Planning Commission

Monday, August 3, 2026 - 6:00 PM

BLAZE MOBILE HOME PARK

RE: Blaze Mobile Home Park - Site Plan Review
SEH No. BALDW 146223

SHEET NO:
C102

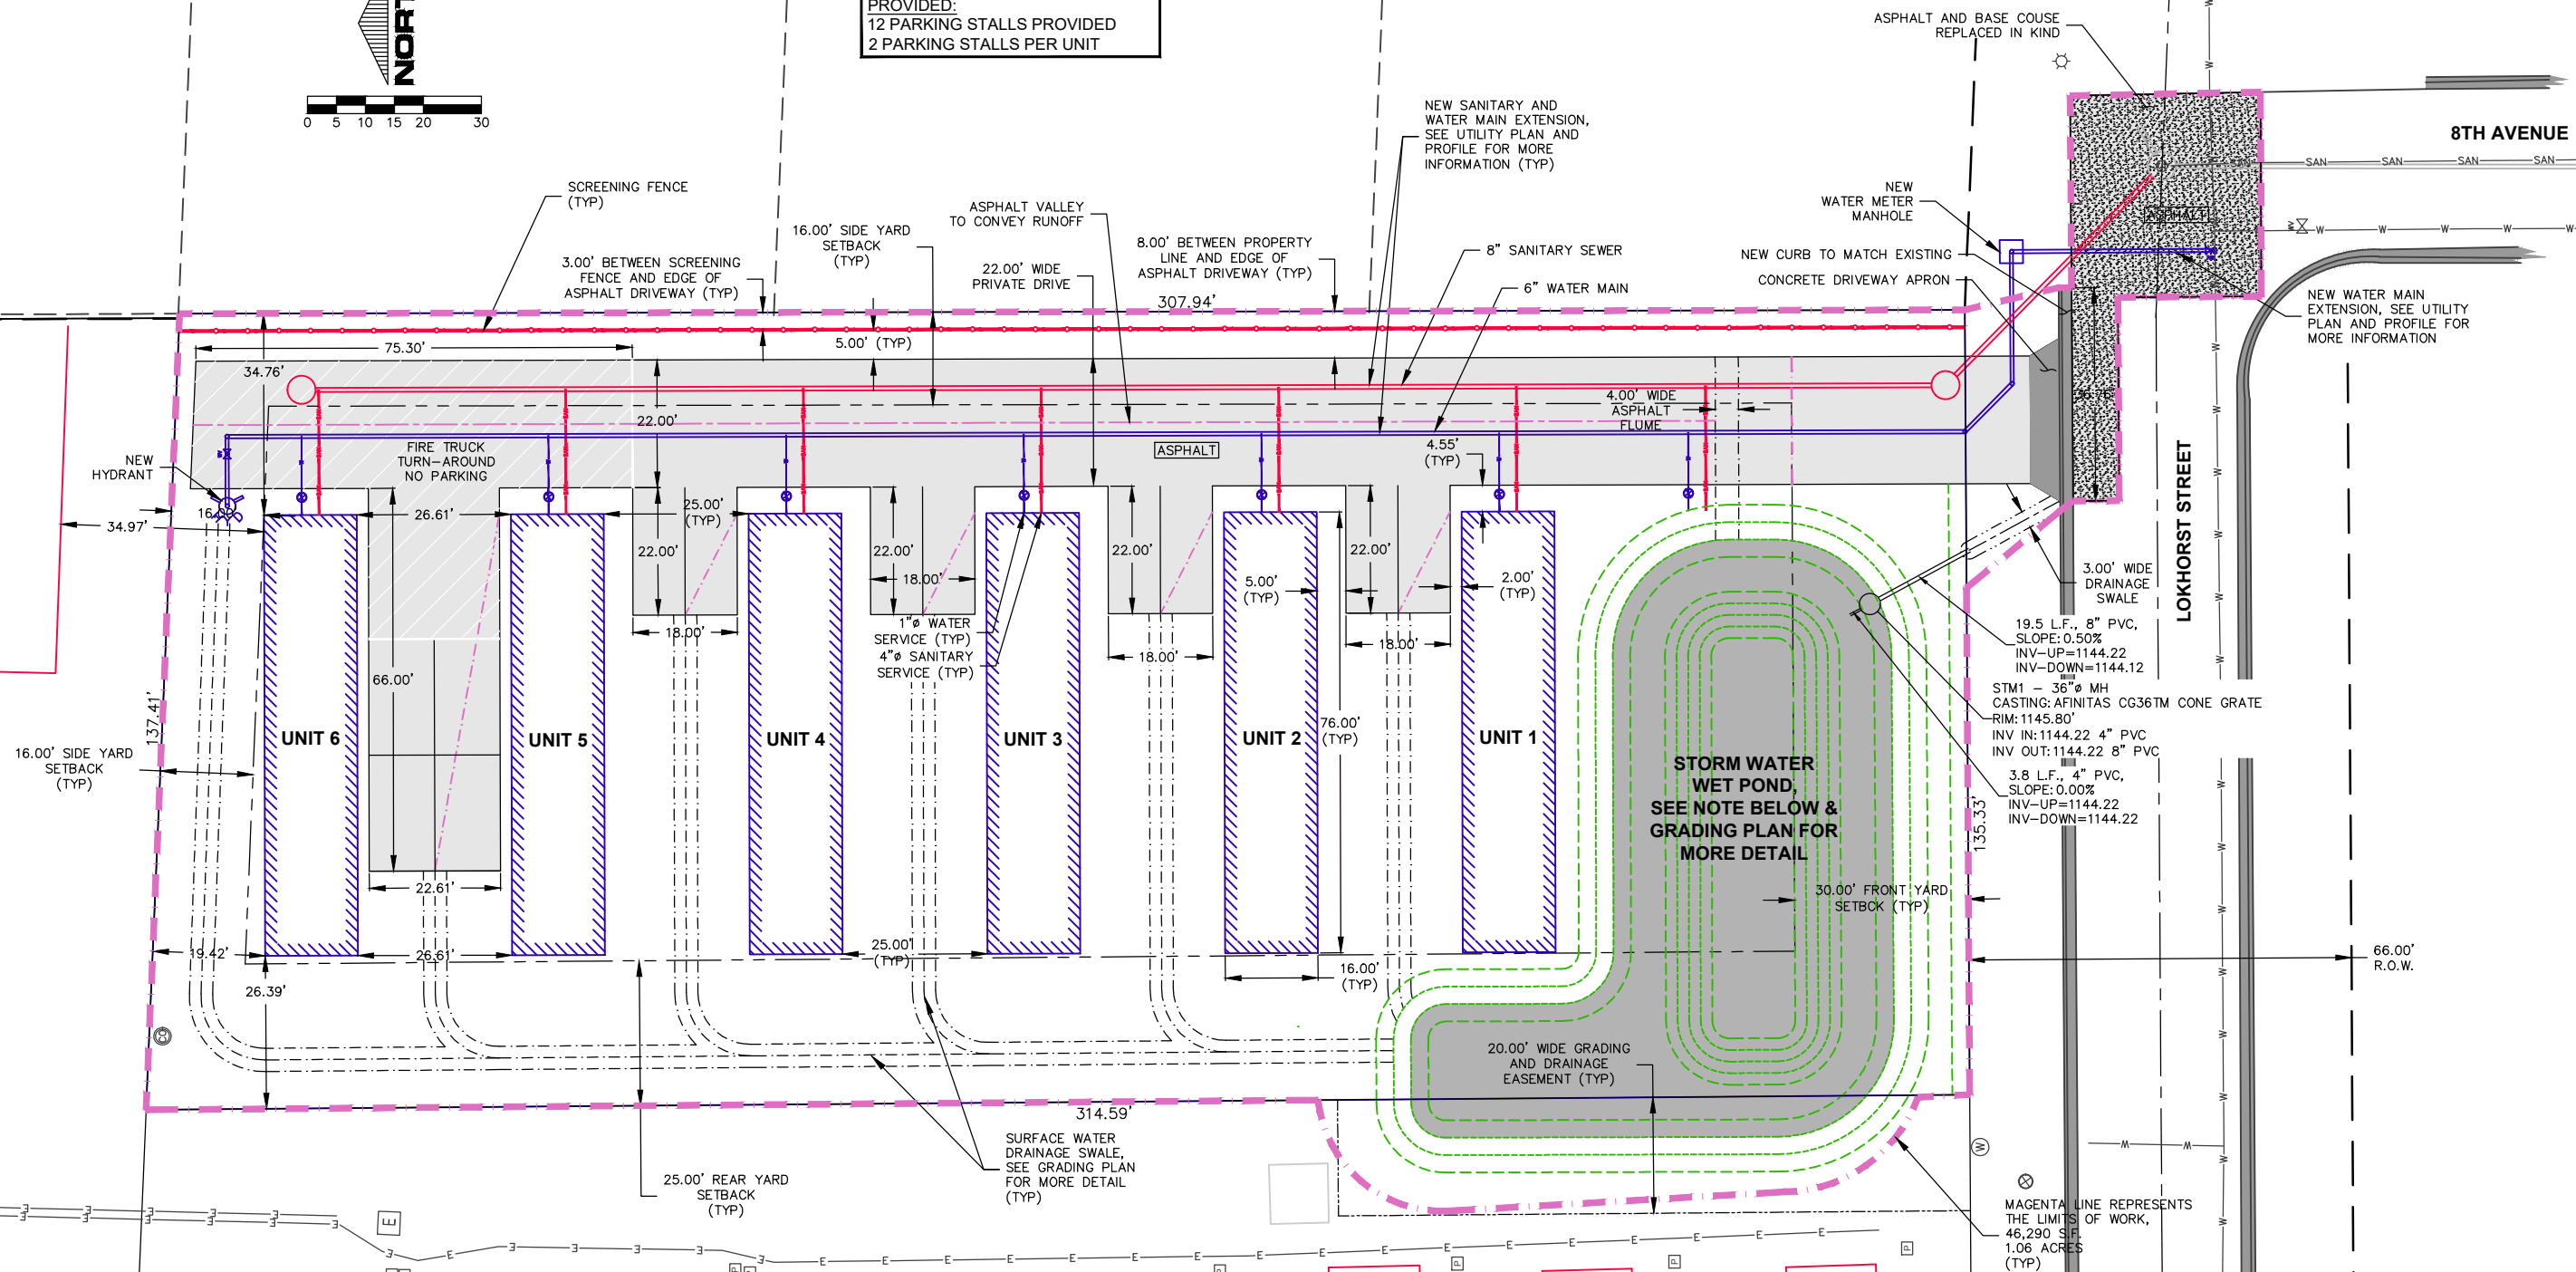
6. Private water and sewer mains are proposed to connect to Village utilities at the north end of 8th Avenue. **A note should be added to the plans to the effect of: any work within the right-of-way and connection to Village utilities to be completed in the presence of a Village representative.**

7. A water meter manhole is proposed to provide one meter to serve the six homes, consistent with other mobile home parks in the Village. **A detail or description of the manhole should be provided for Village staff review. The manhole should include two shutoffs, either side of the meter, to be able to isolate the meter for repairs. (The Village has a manhole base for a 2-inch line that could be utilized for the project.)**

8. **A 6-inch line and meter are expensive and not likely needed to provide service to the proposed six units. It is suggested that the water line be changed to a smaller size, to be determined by the developer, but other lines within the Village are 2-inch. If the line size is reduced it would also be suggested that the hydrant be installed on an existing water main stub in the boulevard, east of Lokhorst St and not at the end of the private drive.**

9. A private 22' wide asphalt driveway on Lokhorst Street is provided for access to all six homes.
10. Per the recent revisions to §271-5, a residential driveway is to be no closer than 5' to the adjacent property line, which is met with the site plan.

11. The driveway is proposed with an inverted crown to collect stormwater runoff and convey to the wet pond along Lokhorst Street.
12. Two parking stalls are required for each unit per § 635-47G(1)(b), and provided on the plan. The parking stalls for units 5 and 6 are located between the homes and also a fire truck turn-around is noted on the plans.

SHEET NO:
C103

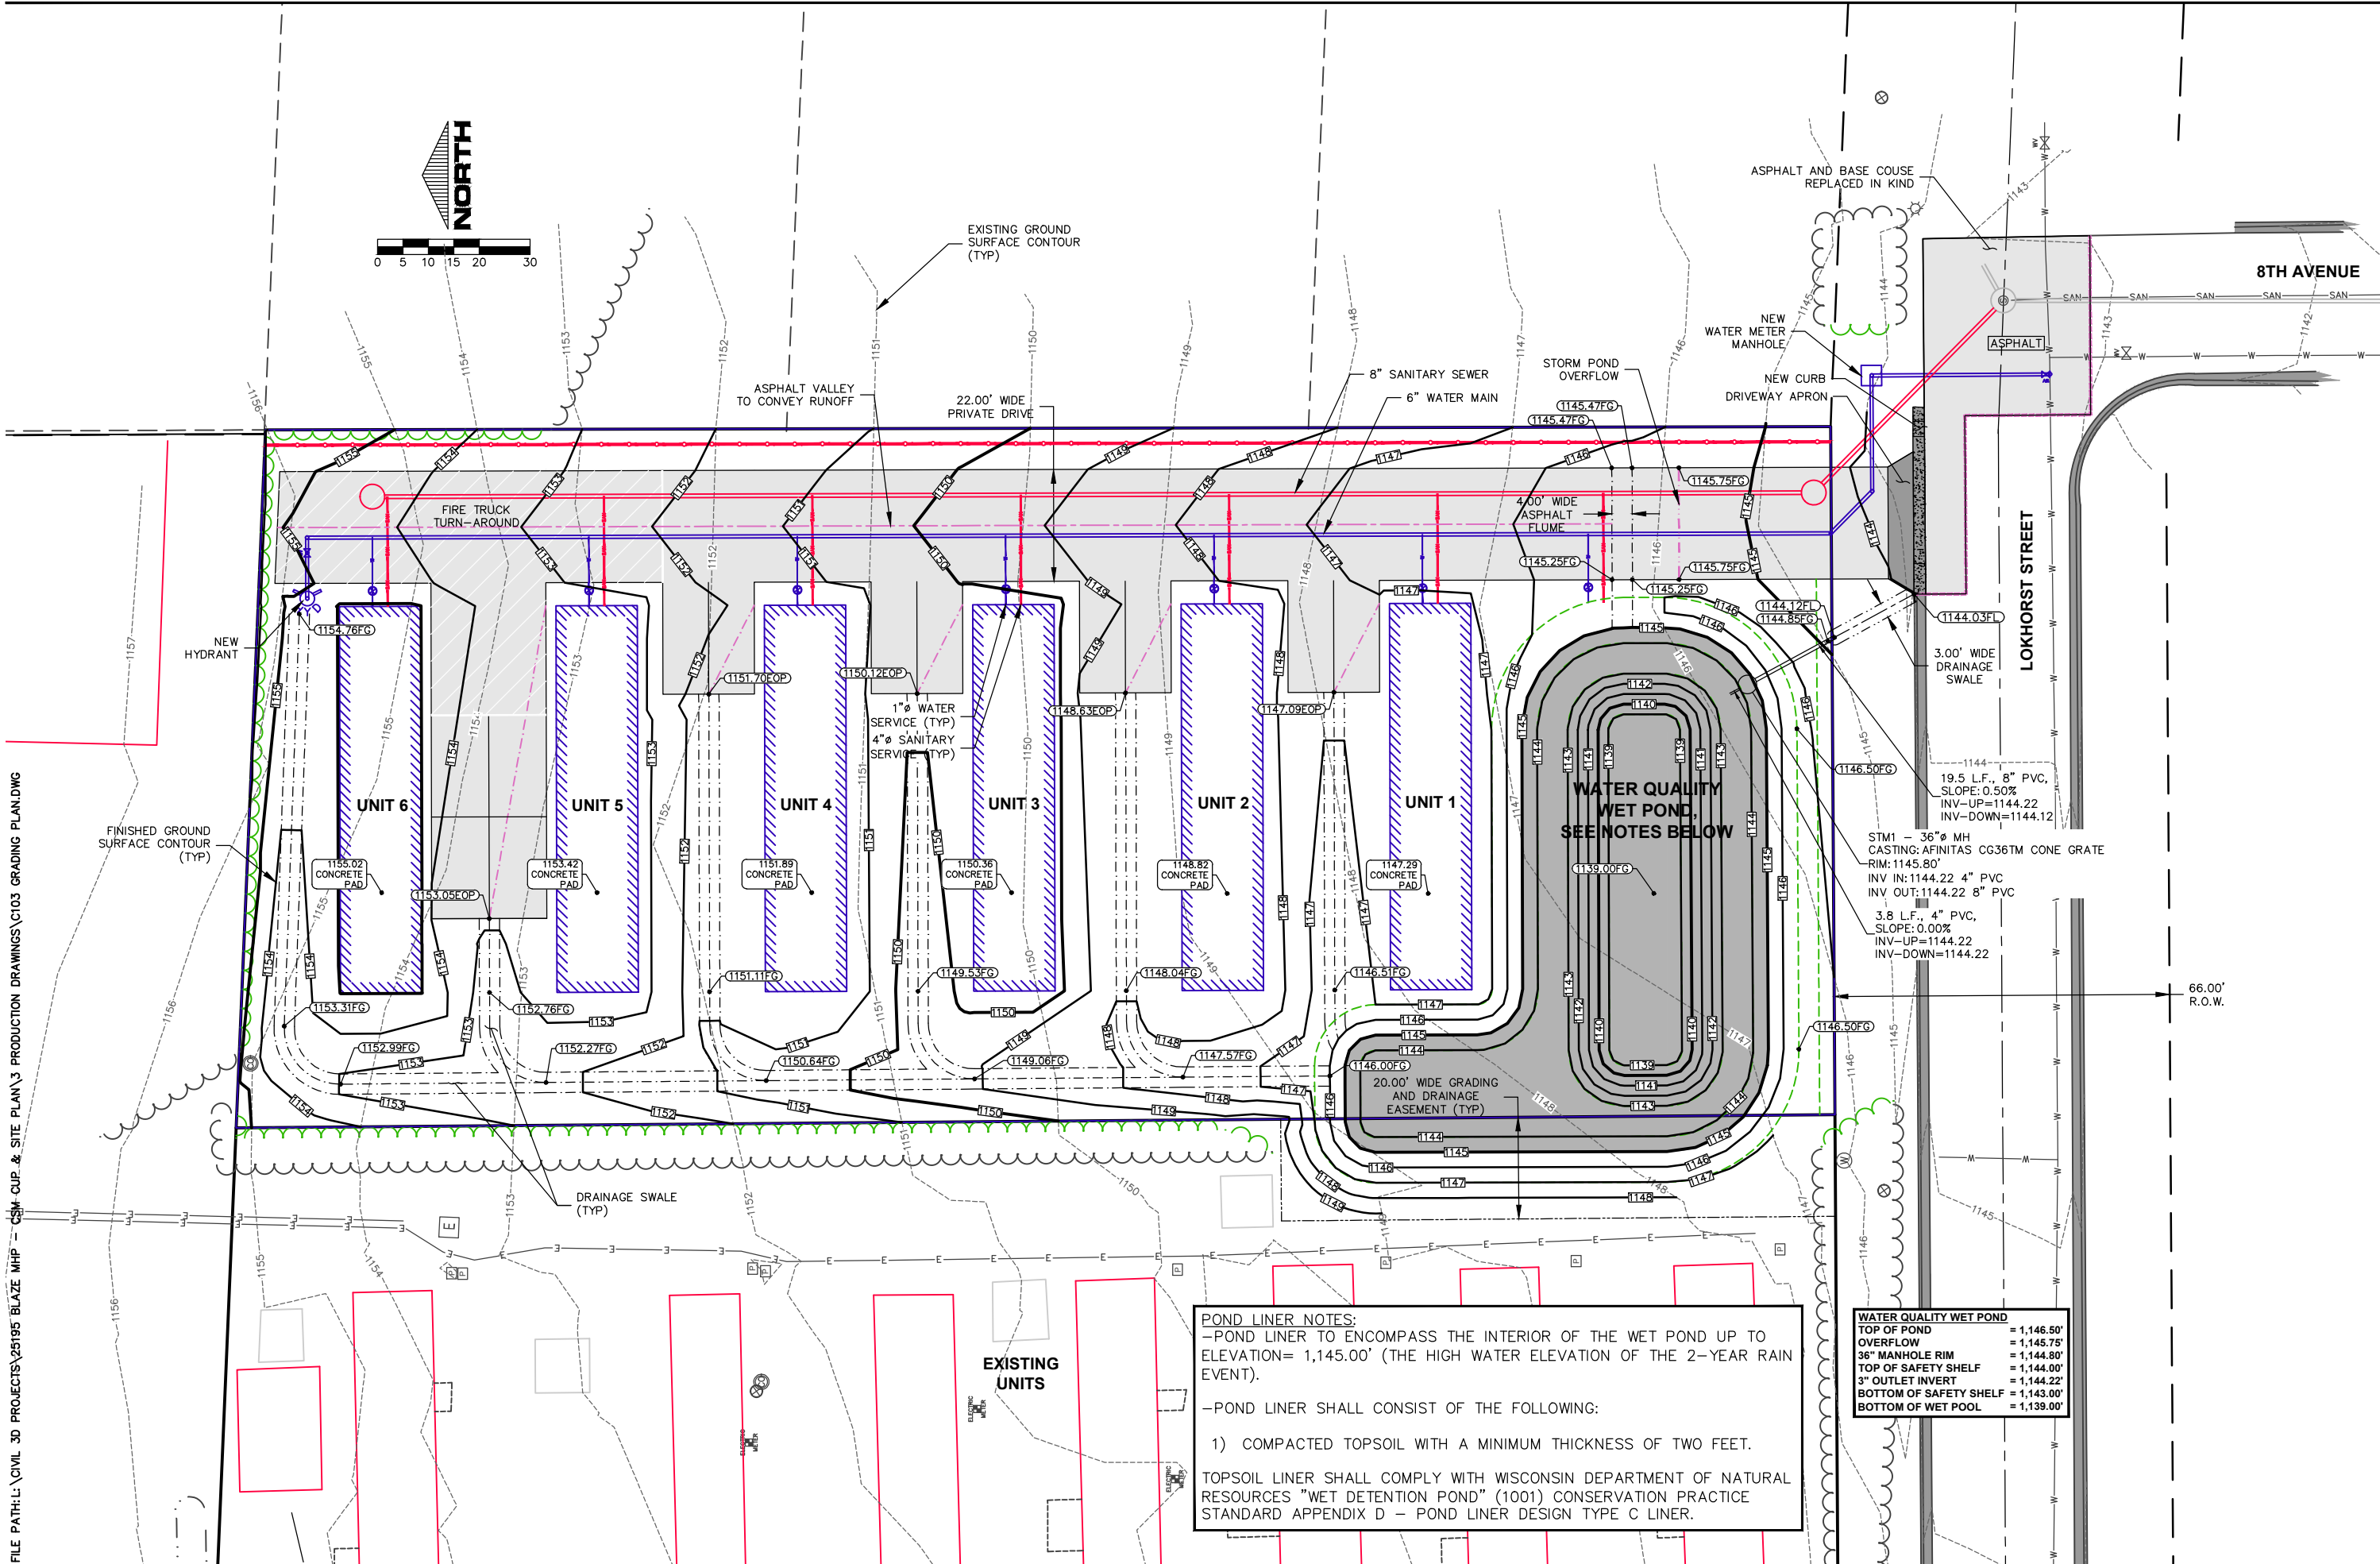
18. Stormwater design document review:
 - a. **HydroCAD modeling for the pond has a rim elevation of 1,144.80' and the plans include a rim elevation of 1,145.80' and 1,145.78'. Update the plans or the modeling to be consistent.**

SHEET NO: C102

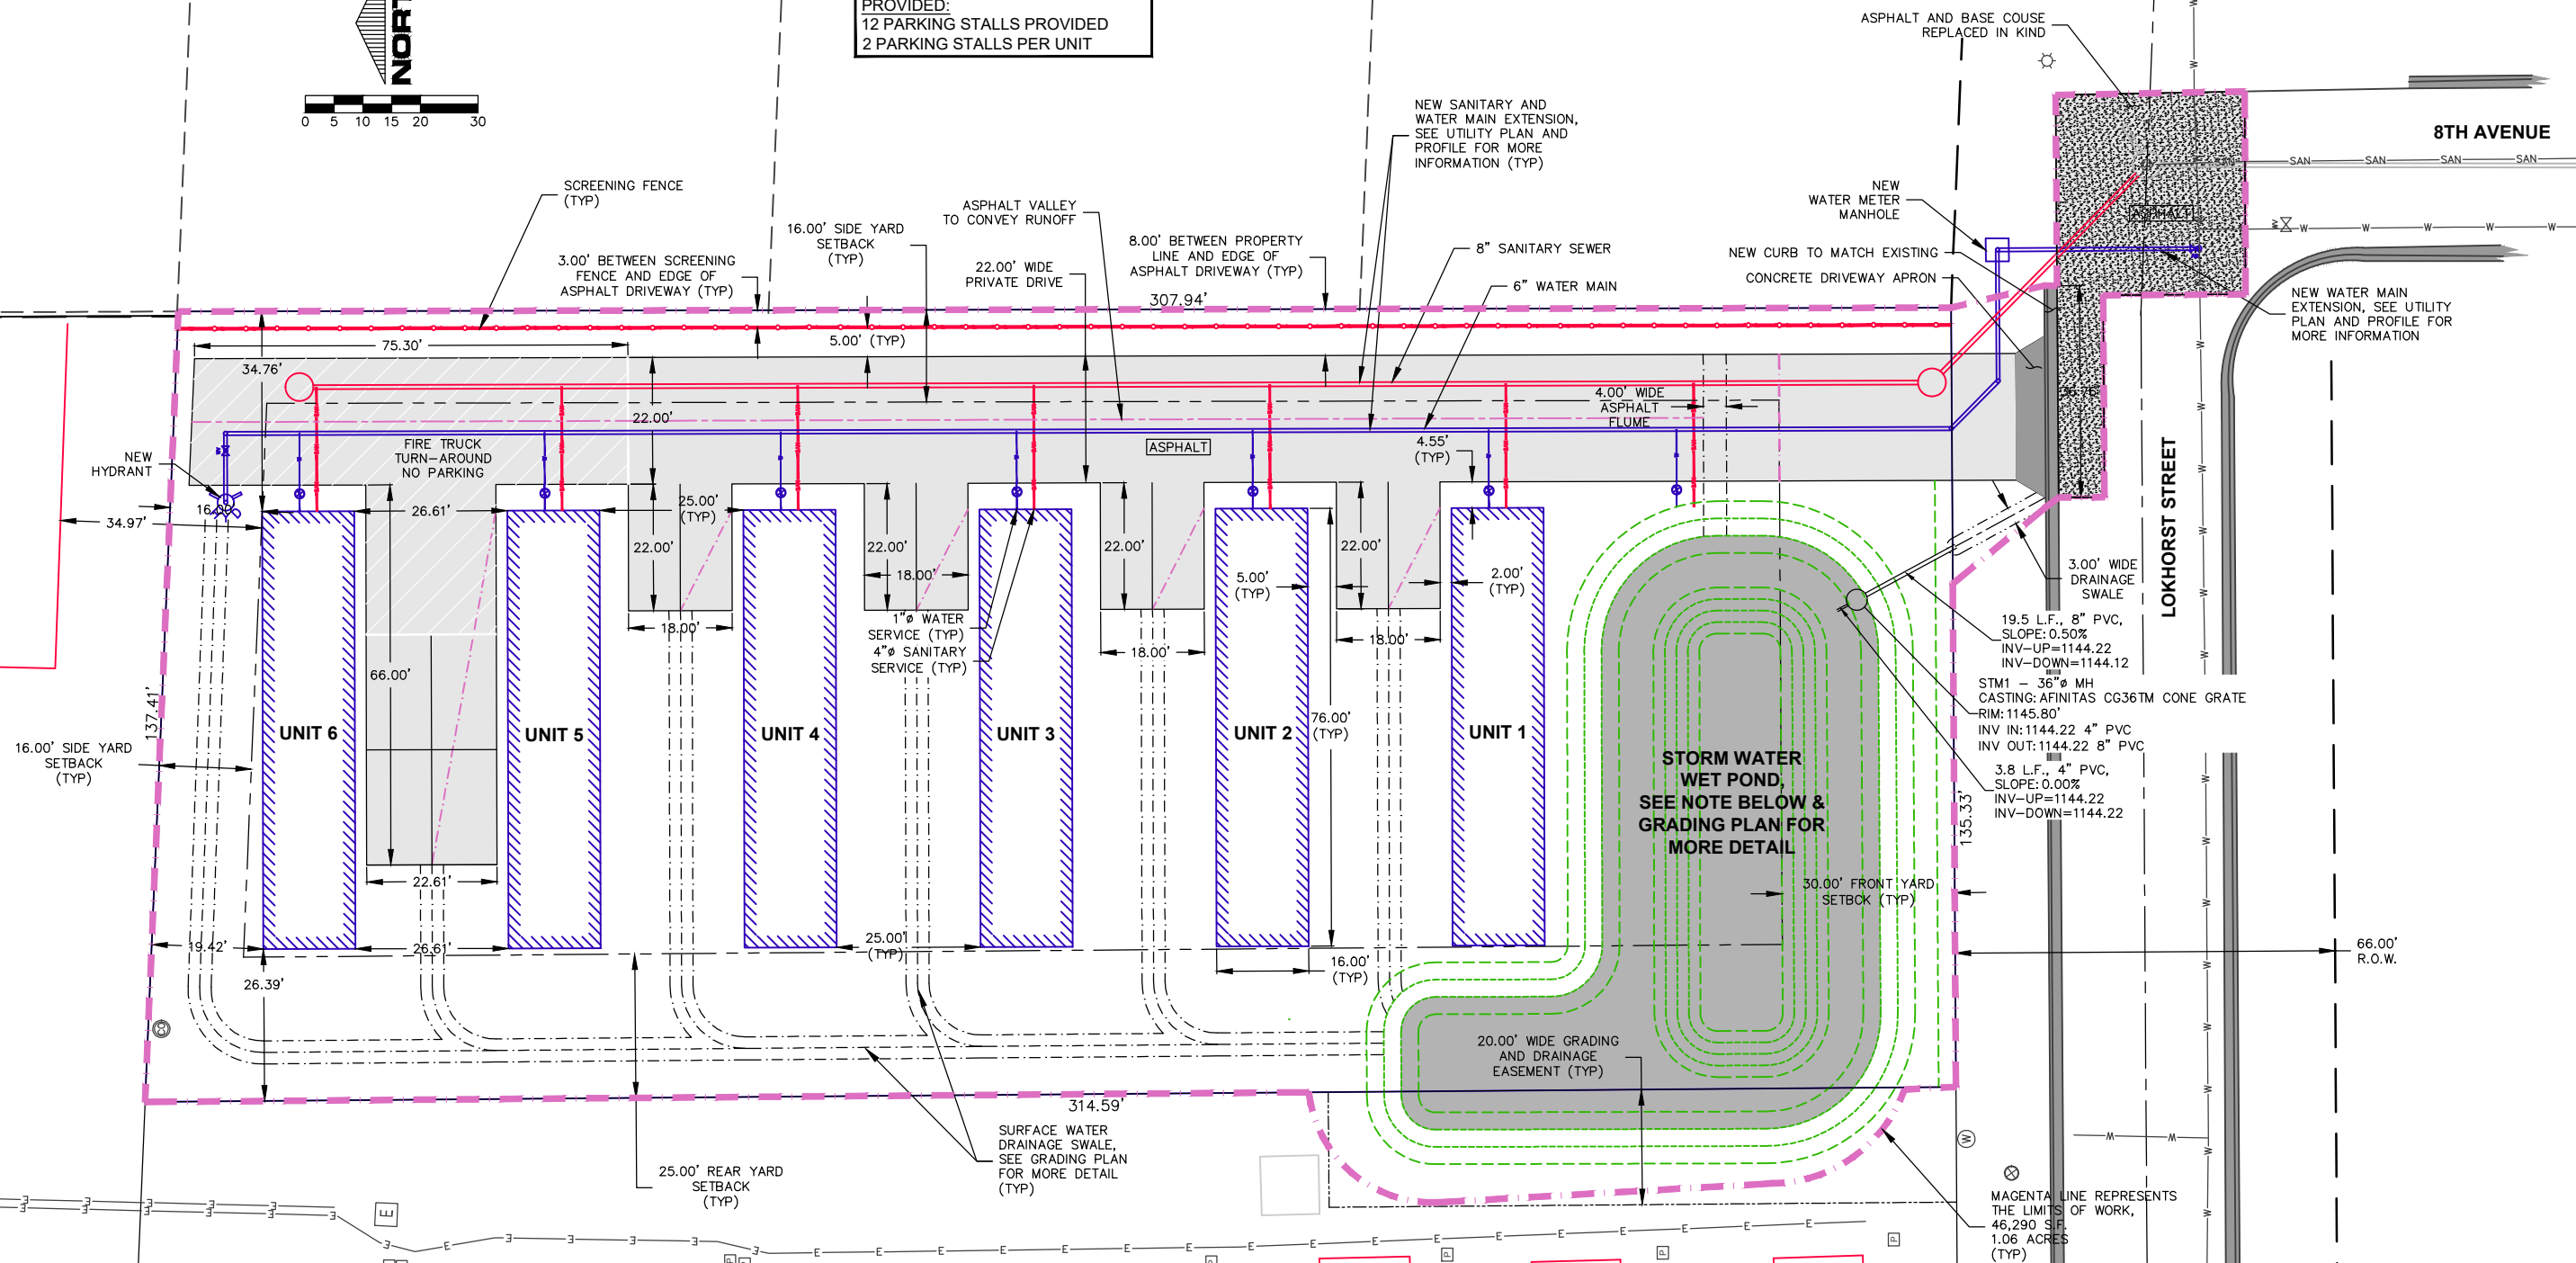
As shown on site plan, it would affect future sales of lots due to lack of adequate setback (5.14ft. with a private road)and no screening.

3.) 5.14 ft. setback shown on site plan is not enough.

4.) Where will tenants park overflow of vehicles? I am sure they will be parking within the 5 ft setback to the east of private road and most likely will be parking on Subdivision lots, unless there is added landscaped buffers(screening.)
